South Sea Street Emergency Access - Consultation Report

September 2016

Figure 2 – Plan of the proposals included in the letter sent to local residents.

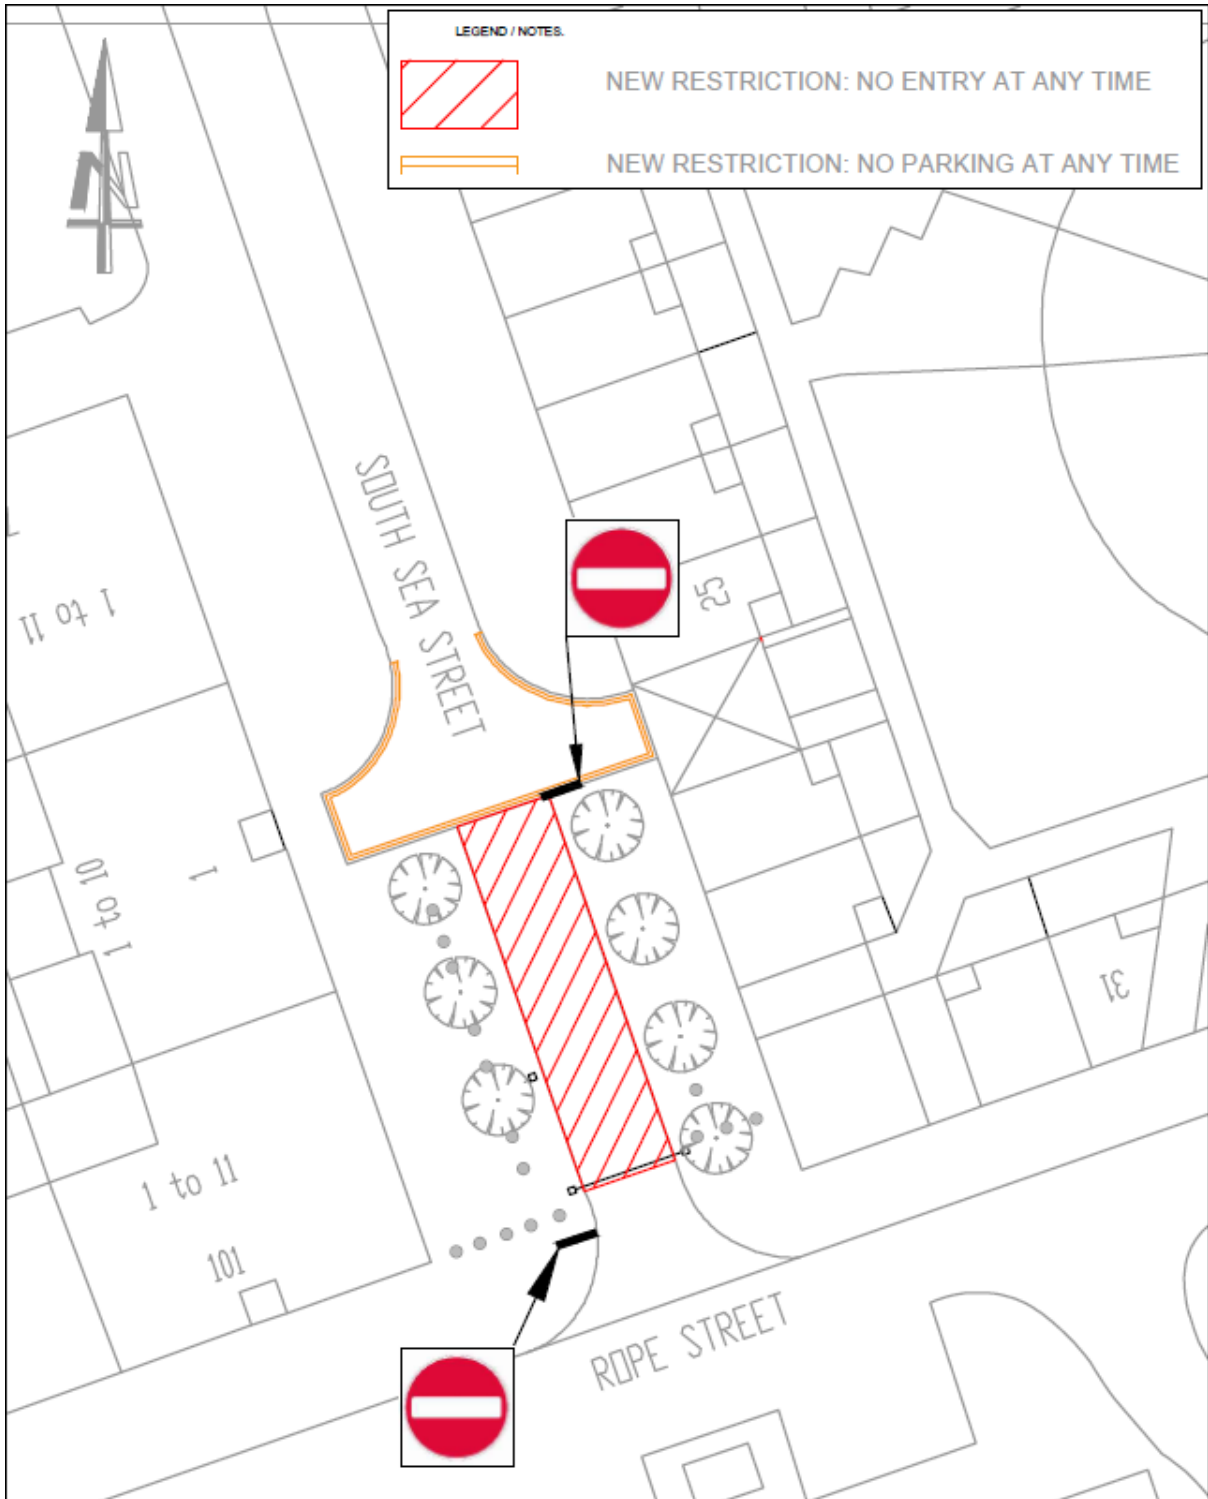
The response to the proposals has been varied. The three “partially support” responses were in favour of not allowing vehicles to pass between South Sea Street and Rope Street, objecting to the additional parking restrictions and the extent of the restricted area.

Loss of amenity to local residents wishing to pass through the gate [to avoid the Lower Road gyratory]

Local residents should be able to park in front of their properties [for a short time]

Response: A physical barrier has existed in this location for at least ten years, possibly even since the estate was constructed. The layout of the highway suggests that the ‘turning head’ at the southern end of South Sea Street was designed to allow vehicles to safely turn around, rather than proceeding through to Rope Street. Therefore, the proposals are considered to be formalising an existing arrangement by which road users should never have been able to pass through on a consistent basis.

Response: The restriction may not be able to be effectively enforced if the entire area is question is not covered by a traffic order. This could render the measures redundant. Should the restricted area be made smaller, there is potential for larger vehicles to drive through too far (in the absence of signage), deem it unsafe to turn around, and proceed through the restriction anyway.

Figure 6 – Vehicle Swept Path Analysis of a standard refuse vehicle attempting a three-point-turn instead of entering the restricted zone.

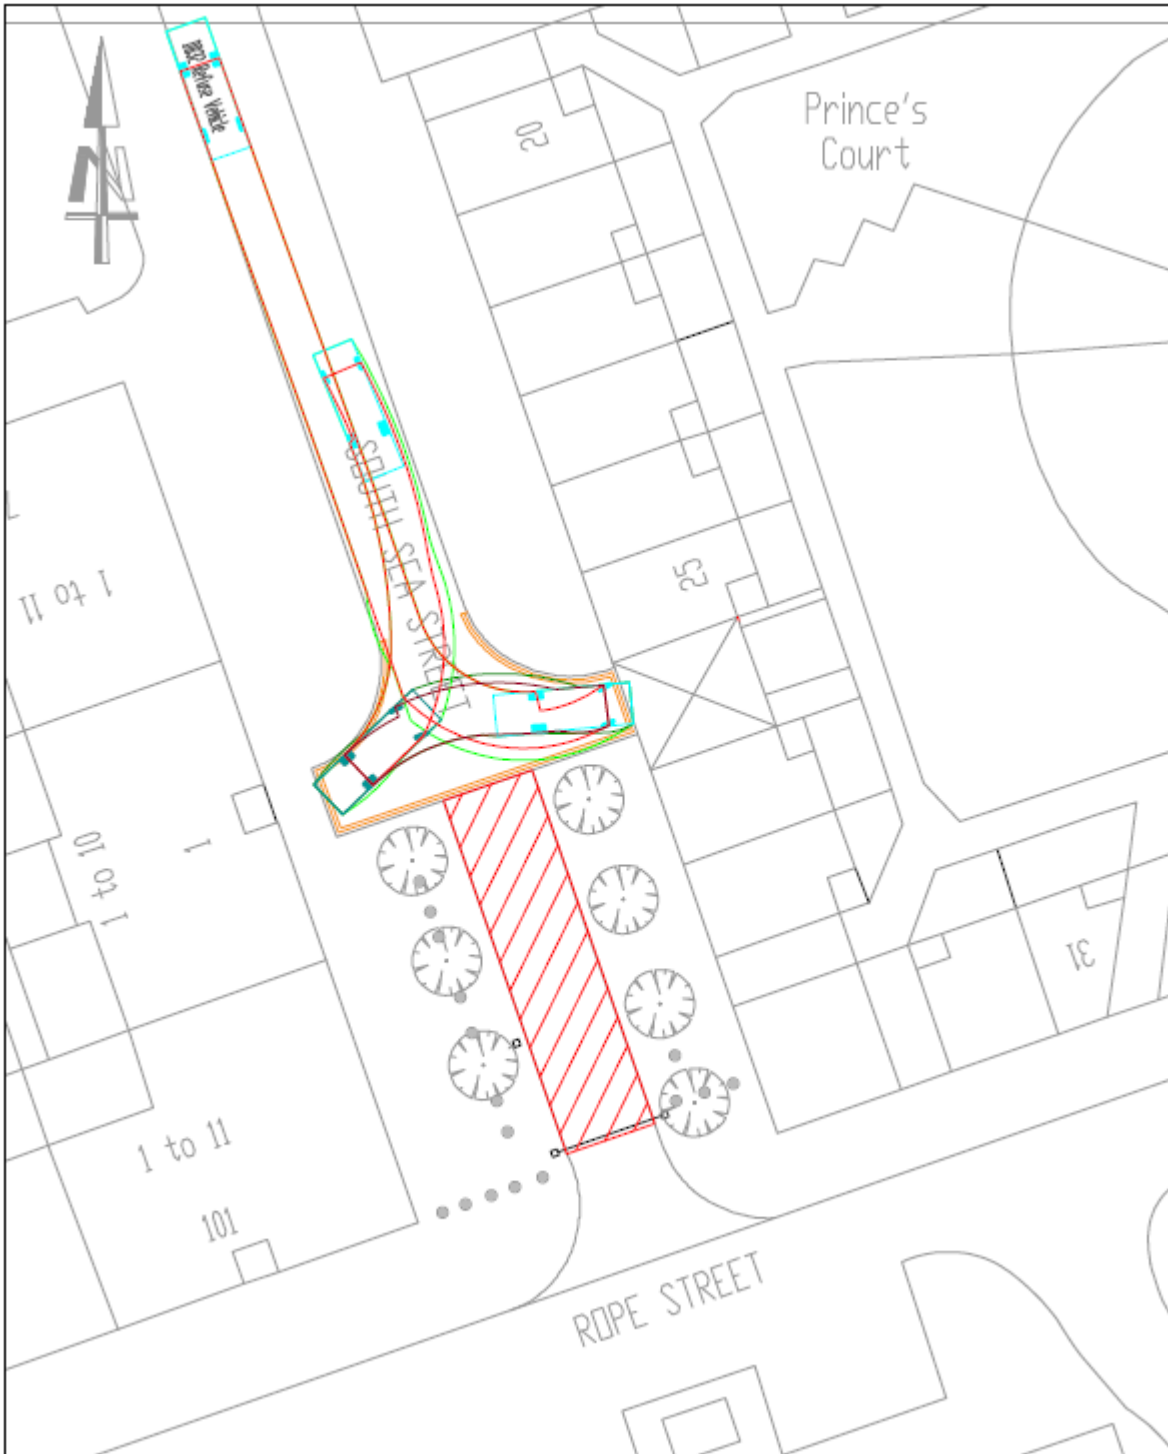
Double yellow line restrictions are not required

Response: Vehicle Swept Path Analysis has been undertaken to show a refuse vehicle undertaking a three-point-turn. While it is acknowledged that public refuse vehicles will be exempt from this restriction, similar vehicles (e.g. delivery lorries) will not. This diagram is shown in Figure 4.
